The sign convention of during load application and when modeling is as follows;

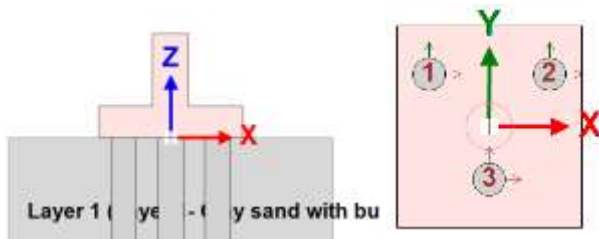
However, when checking the forces there seems to be a discrepancy. Please clarify

Says vertical Force but is given as Fx not Fz. Is this correct? If so Why?

Are the Sign Conventions Correct??
